**1120 John Street**

**Onni Group**

**DRB Recommendation Meeting**

**SDCI Project #3030079**

DRB #1 John Entry Elevation

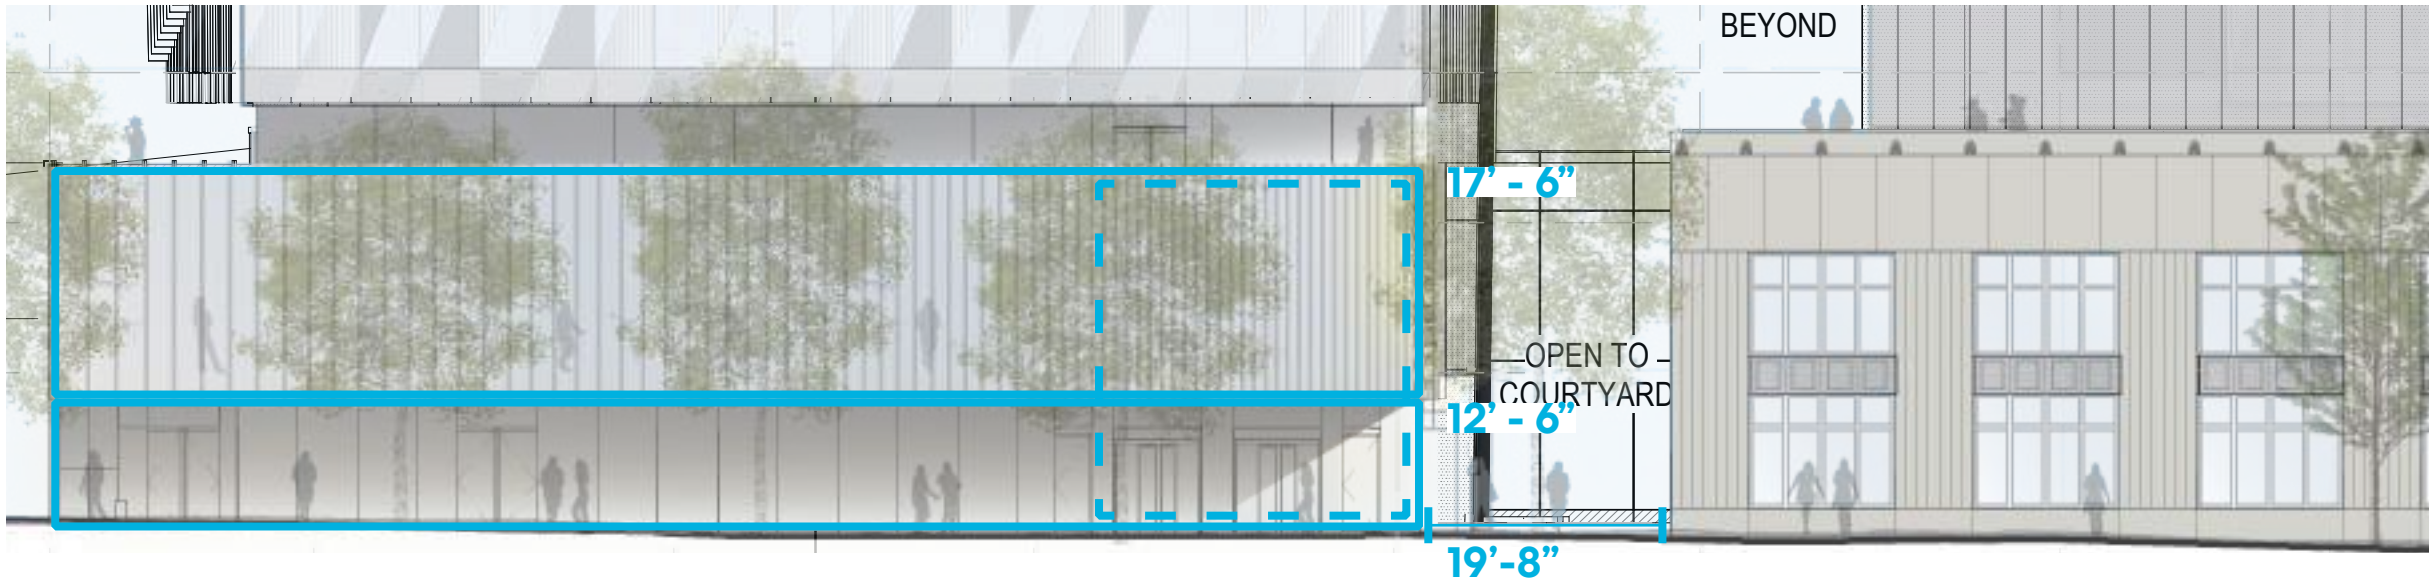
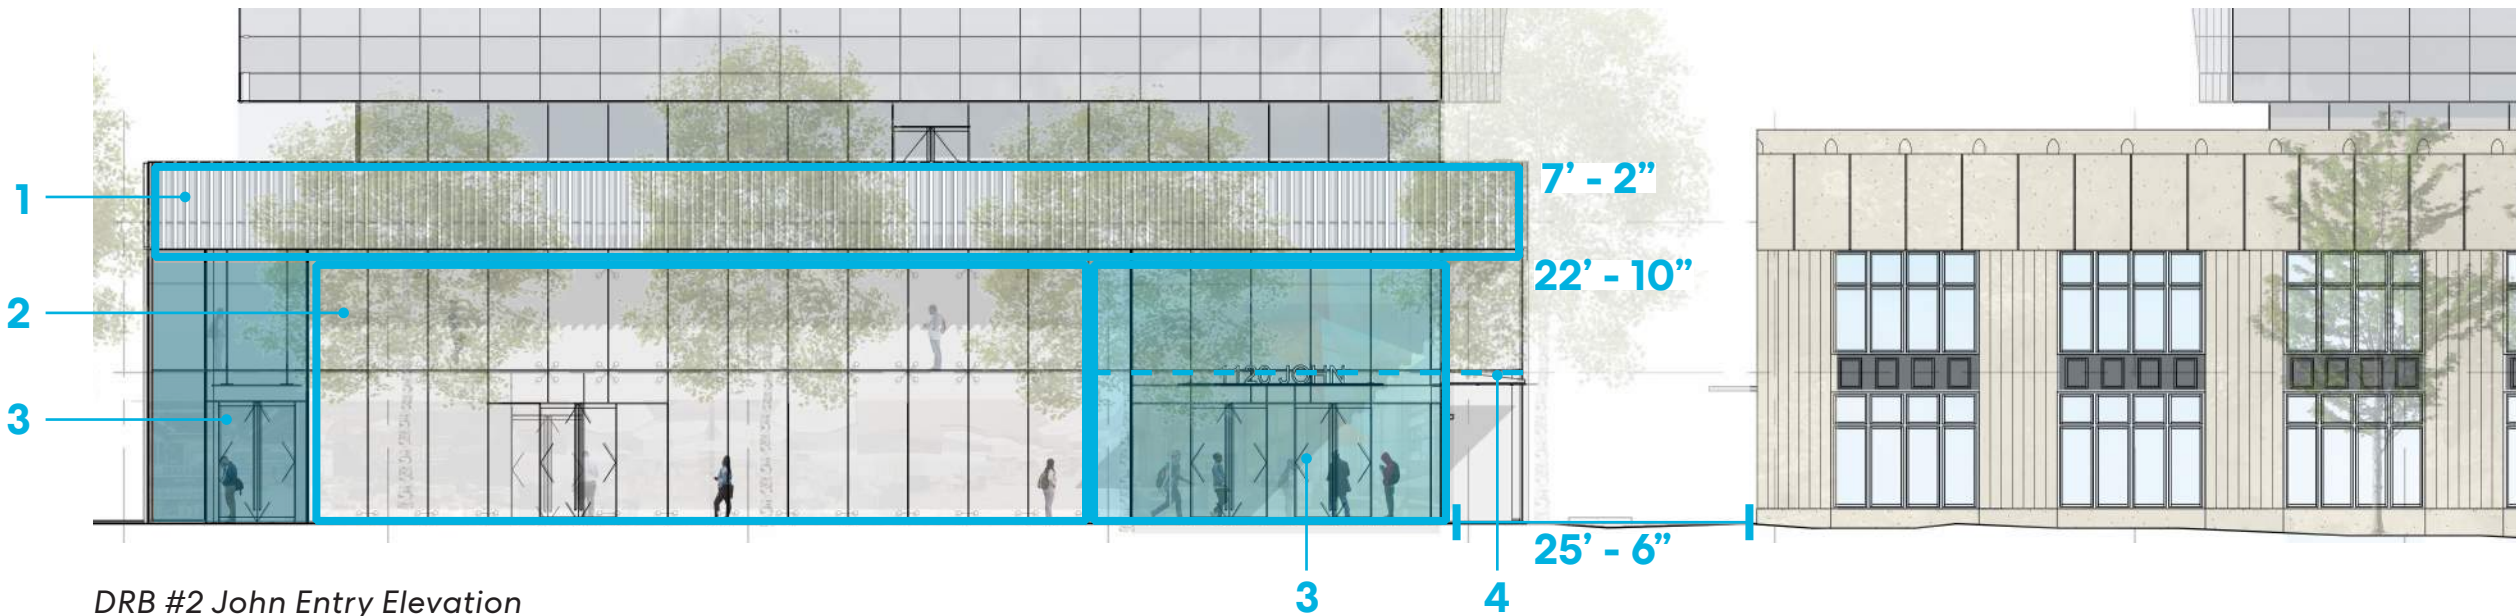
The majority of the Board agreed that further development was required, noting that a clear line of sight through the block did not exist and that the entrance was not yet recognizable as a public passage or sufficiently inviting to pedestrians. (CS2-4-c)

- 1. Raised the soffit to increase the visibility of the entry.
- 2. Modulated the pedestrian level facade to create more visual interest.
- 3. Pushed back the entry to differentiate the facade and signify entry.
- 4. Added a canopy for human scale and weather protection to further signify this as the entry.

The board expressed concerns with the previous iterations of the John Street entry due to the lack of visibility and unrecognizable entry form. Focusing on these two issues and following the guidelines in **CS2-4-C**, the entire facade had been adjusted with differing depths and raised soffits to create a welcoming space for pedestrians to gather. For additional weather protection and to create a more unified appearance amongst all the entries a metal canopy was added overhead as an indicator for entry.

DRB #1 John Entry Plan

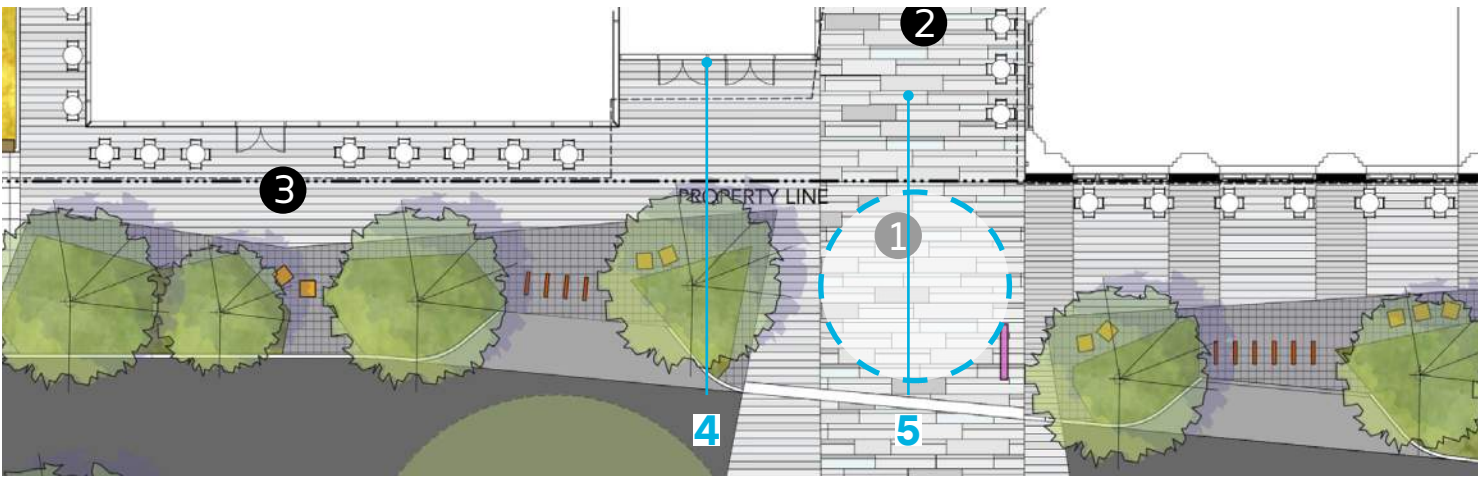
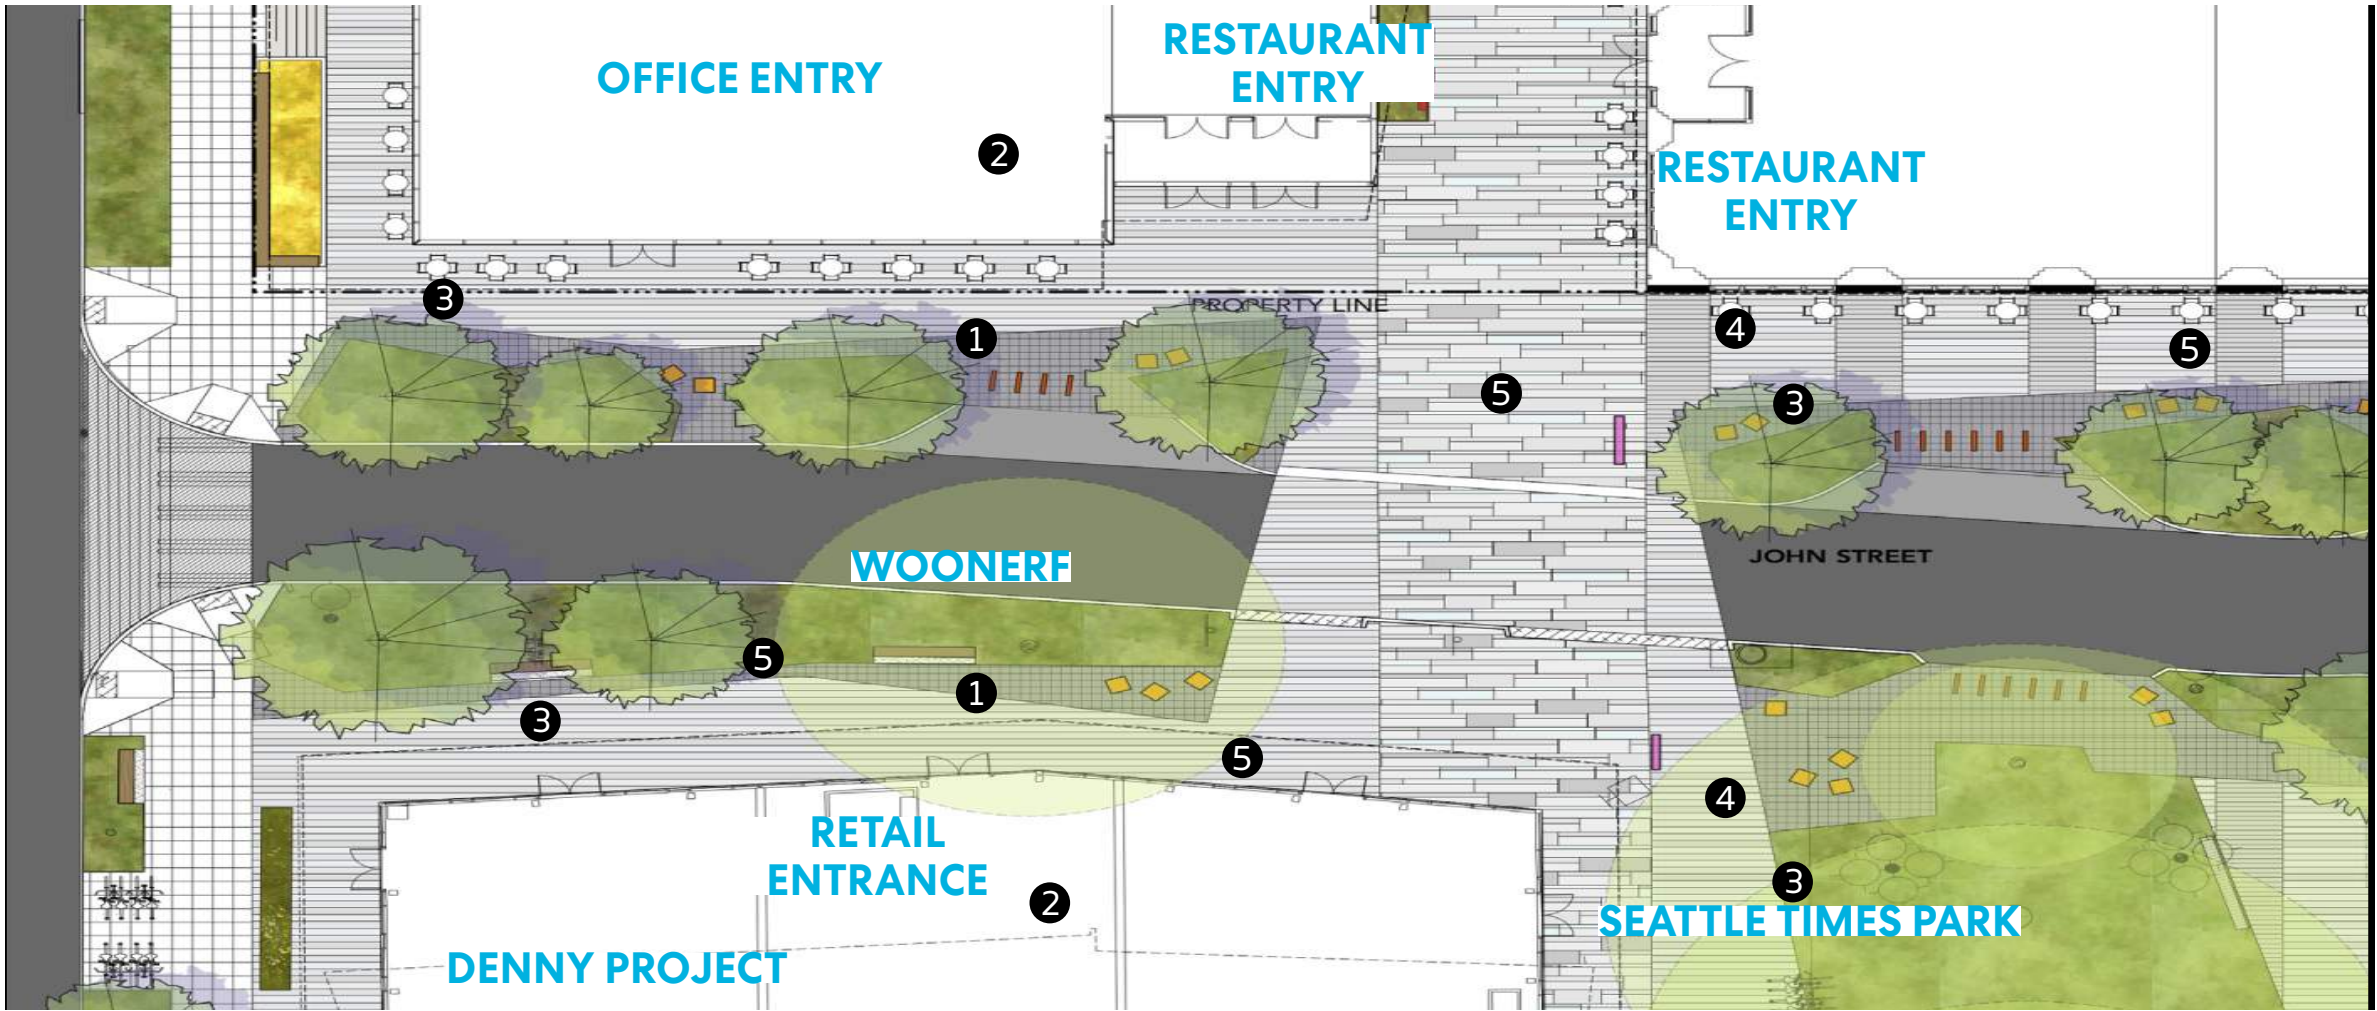
The majority of the Board agreed that they did not yet see the material choices, human scale elements or level of detail in the pedestrian experience that would make the public nature and utility of this entrance legible. (CS2-4)

- 1. Soffit was raised for increased visibility into the Paseo.
- 2. Metal canopy was added for weather protection and to signify entry.
- 3. Entry facade has been recessed to create an open area for pedestrians to gather.
- 4. Recessed facade for pedestrian circulation.
- 5. Special paving pattern to signify entry.

DRB #1 FAIRVIEW MID-BLOCK CONNECTION PLAN

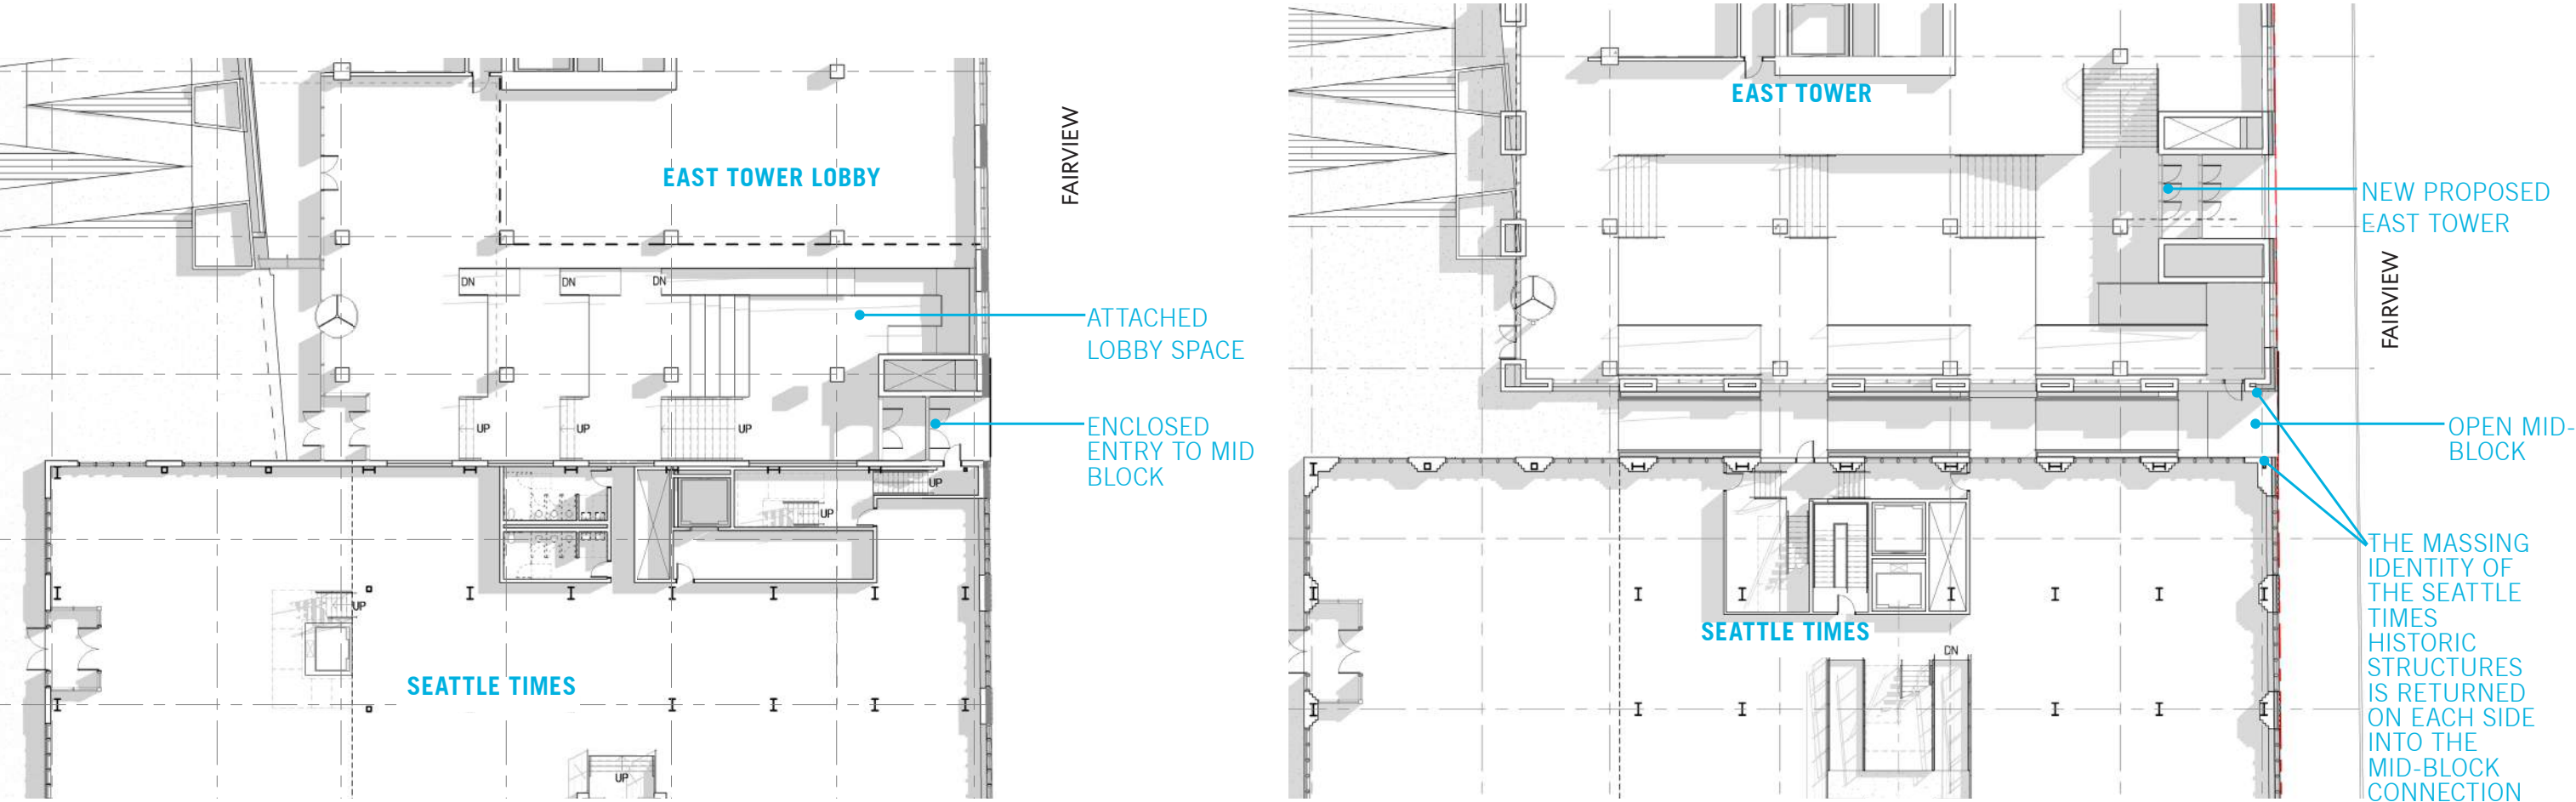
Echoing public comment, The Board was unanimous in support of the development of this entry as an open passageway rather than an enclosed space, noting that even if it were underutilized, the intent of the code and guidelines is for unfettered public use. (CS2-4-c)

- 1 Fairview Mid Block connection is now an open thoroughfare connecting street and paseo
- 2 Added entry on Fairview Avenue
- 3 The massing identity of Seattle Times historic structures is returned on each side into the mid-block connection

The Fairview mid-block connection is now an open passageway which allows people to access the paseo freely. The entry is open without any interruption of connection or enclosed space, a requirement explicitly stated in **CS2-4-C-1**. An overhead glass canopy was added to protect those passing through from the elements.
